**BEFORE THE  
PUBLIC SERVICE COMMISSION OF WISCONSIN**

**Application of Wisconsin Electric Power Company  
for a Certificate of Public Convenience and Necessity  
to Construct and Operate the Paris Reciprocating  
Internal Combustion Engines Project, Consisting of Seven  
Natural Gas-Fired Reciprocating Internal Combustion  
Engines Generating up to 128 MW Total at the  
Lakeshore Capacity Improvement Project Regulator Station  
in the Town of Paris, Kenosha County, Wisconsin**

6630-CE-316

**DIRECT TESTIMONY OF CHELSEA HOTALING  
ON BEHALF OF CLEAN WISCONSIN**

10 **Figure 1. WEPCO Modeled Portfolio Cumulative Builds Through 2030 (MW)<sup>29</sup>**

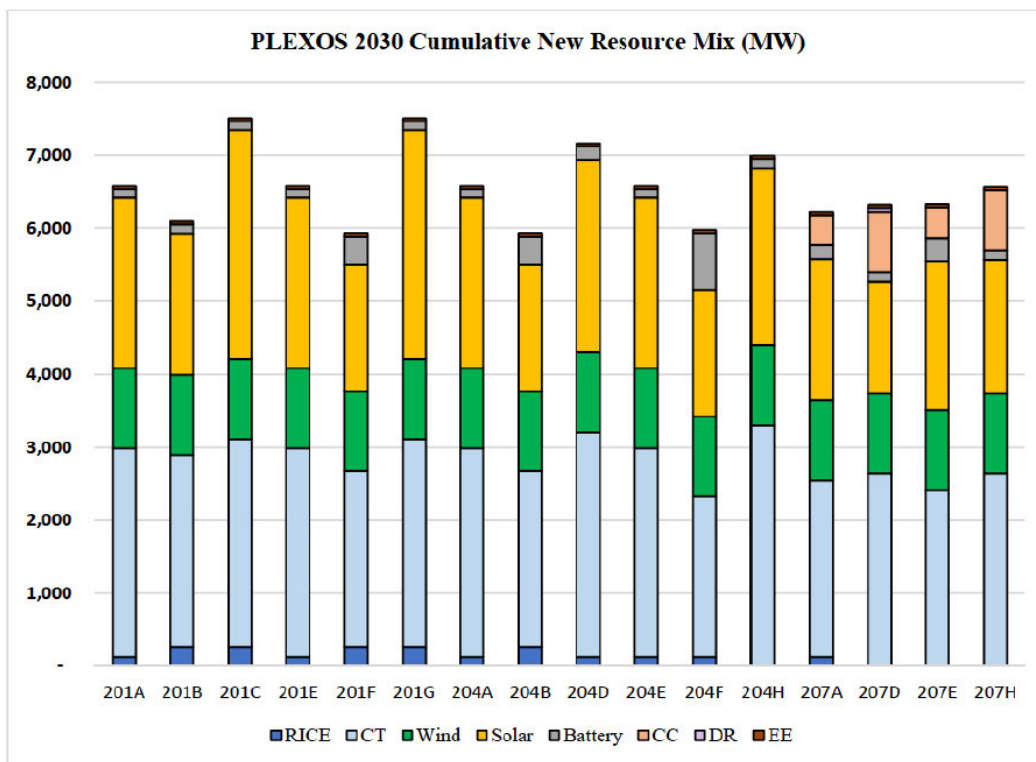
3 A. Yes, there is. These results are consistent with the different modeling runs that WEPCO  
 4 performed for this Application. PLEXOS selects additional generic resources, including CTs,  
 5 CCs, RICE units, solar, wind, battery storage resources, demand response, and energy efficiency.  
 6 Figure 1 below shows the cumulative new resource additions for a portion of the modeling runs  
 7 that WEPCO performed for this Application. As can be seen by the blue shaded bars, there is a  
 8 level of generic CT and RICE builds above the capacity that can be provided by the Paris RICE  
 9 or Oak Creek CTs, which is 128 MW and 1,185 MW, respectively.
